Access Compliance Report

Public Rights-of-Way

Intersection ID: 54465	Main Street: RUPELL_DR	Cross Street: COLLINGHAM_DR	Location: NW
ADA ID: B09371C85A7C	Ramp Type: BlendTrans1	Initial Pass/Fail: Fail	Overall Compliance: No
Codes/Mitigation Info/Possible Solution			Severity Score: 10
			Field Measurements/Component Compliance

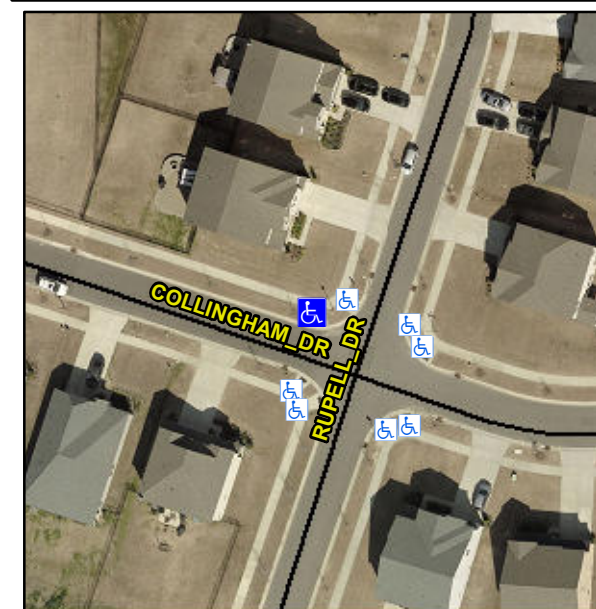
Not Found, R304.5.1, R304.5.3

Remove & Replace Curb Ramp With Two New Directional Ramps or Equivalent.
